Appl. No. 10/537,111

Amdt. Dated June 25, 2008

Reply to Non-Final Office Action dated Feb. 26, 2008

Fig. 1a

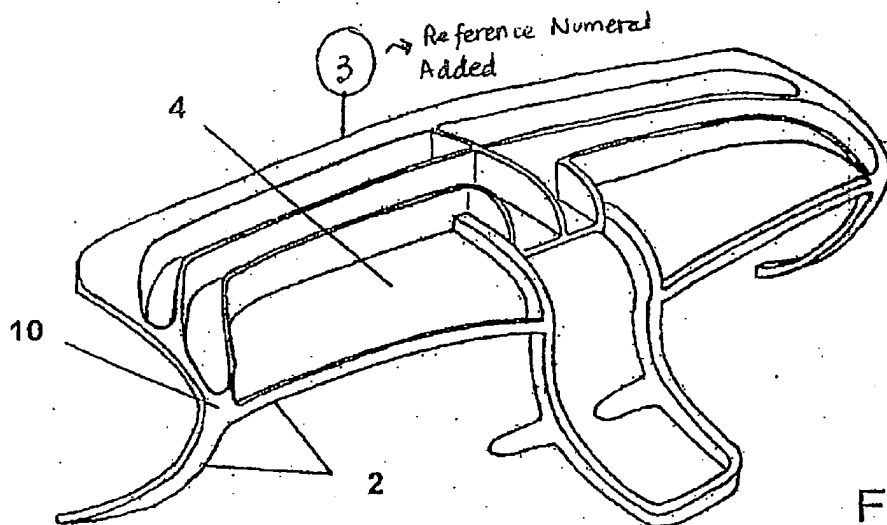
The Examiner has objected to the drawings because of some informalities. (*See* 2/26/08 Office Action, p. 2). Specifically, the Examiner states that Fig. 1a requires reference numeral 3 to be added; the term "EBENE" from Fig. 1b should be amended to "cut-plane"; and the term "Schnitt B-B" from Fig. 2d should be amended to "cut-line." Figs. 1a, 1b, and 2d have been amended according to the Examiner's suggestions.

The first of the attached sheets of drawings includes changes to Figs. 1a-b. This, sheet which includes Figs. 1a-b, replaces the original sheet including Figs. 1a-b. In Fig. 1a, reference numeral 3 has been added. In Fig. 1b, the term "EBENE" has been replaced with "cut plane," reference numeral 2 has been moved, and an end wall 12 has been added. An annotated sheet indicating the above amendments has been provided.

Fig. 1b

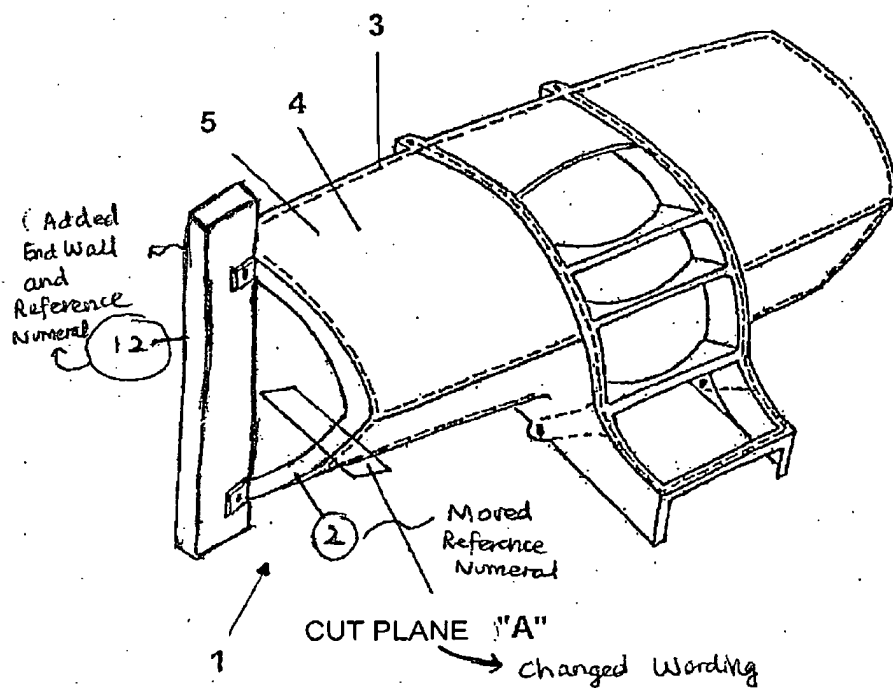
The Examiner has objected to the drawings under 37 CFR 1.83(a) for not showing every feature of the invention specified in the claims. (*See* 2/26/08 Office Action, p. 2). Specifically, the Examiner states that the figures must show "at least one of an end wall of the vehicle and a body of the vehicle," as recited in claim 24. Fig. 1b has been amended to show this feature by added an end wall 12. The Specification has been amended to address this new reference numeral. Specifically, paragraph [0043] has been amended to include the new reference numeral 12.
